JAYNE'S PROPERTY SKETCH PLAN

LETTER OF INTENT

AUGUST 2022

- SKP225

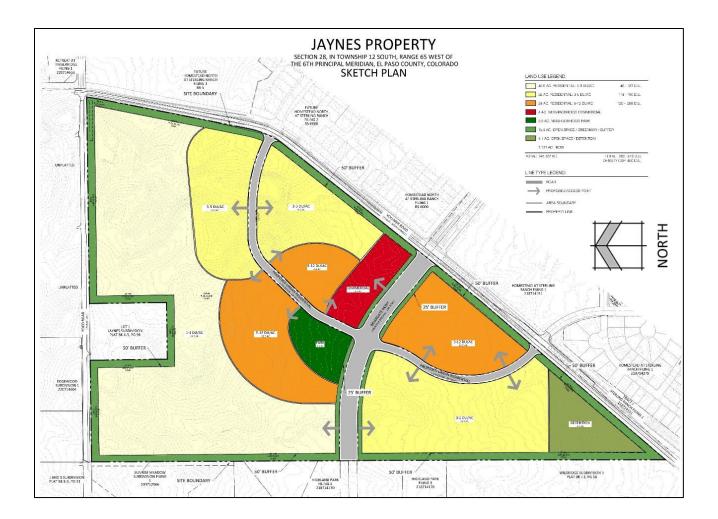
Add statement that all proposed access will be reviewed with

subdivision applications.

YOUR EL PASO MASTER PLAN

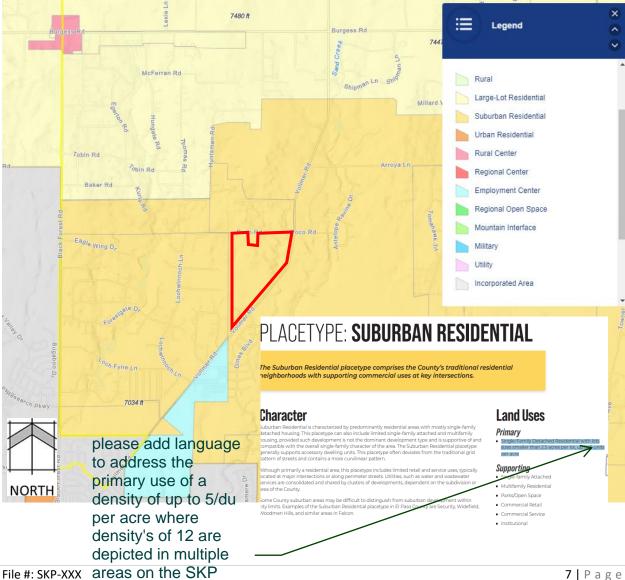
Plan. Density seems to be one of the issues with the adj property owners so it should be clarified.
